# Ailunce HD1 Software and Firmware Revisions Records

## Firmware V1.77

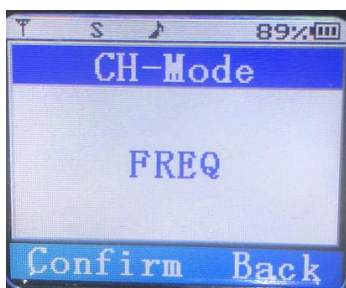
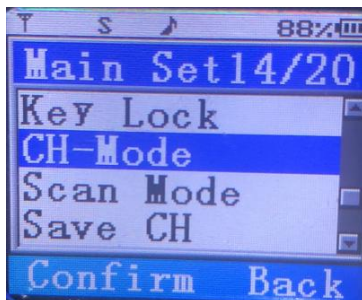
1. Allows users to make changes in radio menu.

2. The receiving and transmit display will change with the CH-Mode you selected.
